Midway City Council
5 October 2021
Regular Meeting

Eddington Subdivision /
Preliminary and Final Approval

CITY COUNCIL MEETING STAFF REPORT

Subject: Eddington - 1 lot Subdivision – Preliminary / Final Approval

PROJECT: EDDINGTON LOT SPLIT
 SHEET TITLE: SITE UTILITY PLAN
 PROJECT: C21-030
 SHEET: 1

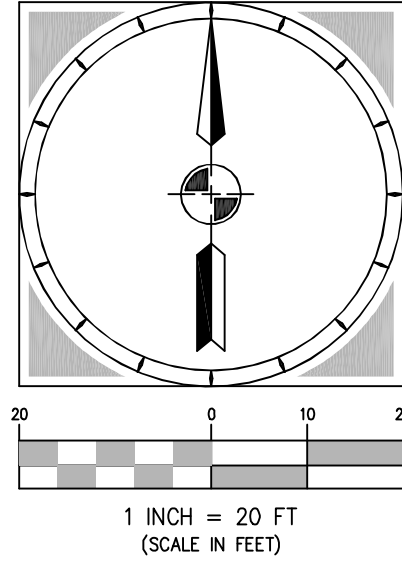
Culinary Water Connection – The lot will connect to the City’s water line located in 500 South. They will need to extend the line to their west property line in 500 South.

Fire Flow - A fire hydrant will need to be located within 600’ of the future dwelling, measured by the route of a fire hose from the fire hydrant to the future home site.

- The proposed development will be served from the Gerber Mahogany pressure zone.
- A fire hydrant should be within 600' of the proposed home.
- The development should extend the existing 8" water line to the west side of the development property line.

- The proposed lot will need to provide a location and size of meter for the connection to the irrigation main in 500 South.

EDDINGTON ONE-LOT SUBDIVISION

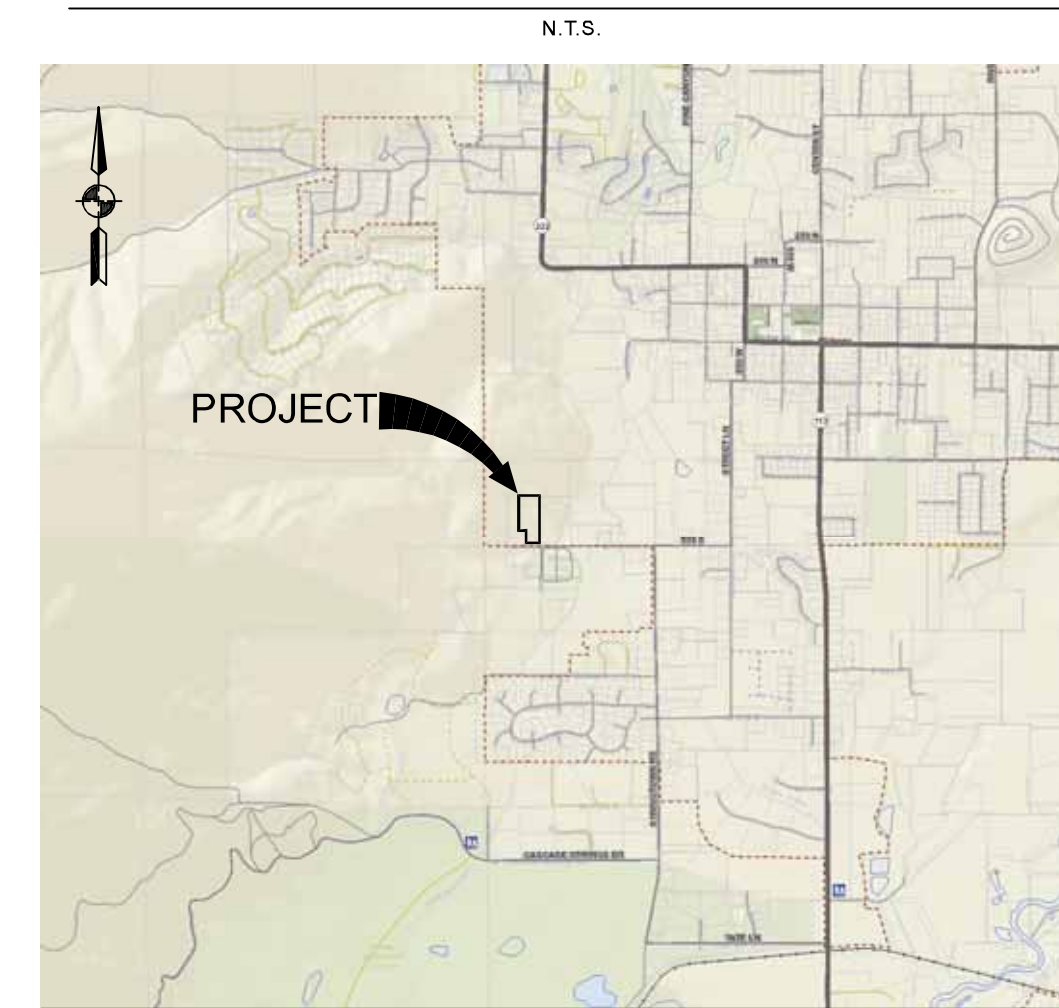
Sewer Connection – The property will be served by an onsite septic system that will be approved by the Wasatch County Health Department. An approval letter from the Wasatch County Health Department regarding the septic system, must be provided before the item is added to a future city council agenda. The location of the approved septic site should be noted on the plat.

Sensitive Lands – The applicant has identified all slopes of 25% and greater on the site. These need to be noted on the plat and labeled as unbuildable. No other sensitive lands were identified by the applicants engineer.

Setbacks – The small-scale subdivision code requires a 50’ front setback for any proposed structures fronting 500 South. The required setback must be noted on the plat.

500 South – The applicant will need to show any required dedication needed for 500 South on the proposed plat. The portion of 500 South in front of the applicants property is considered a local road with a 56’ ROW. There are no additional road improvements that will be required as part of this proposal.

Trail – The Midway City Trail System Master Plan shows an 8’ detached asphalt public trail along the portion of 500 South that this property fronts. The applicant will need to dedicate a 15’ public trail easement along their front property line. In addition to the easement, staff is proposing that the funds to build the trail are added to the general trails fund for the city and the trail is completed in the future as part of a larger improvement project that will complete the trails along 500 South. The applicant has provided an estimate of probable costs, which has been reviewed by the city engineer, Wes Johnson. Wes has indicated that he is comfortable with the total trail construction cost identified by the engineer of \$9,803.
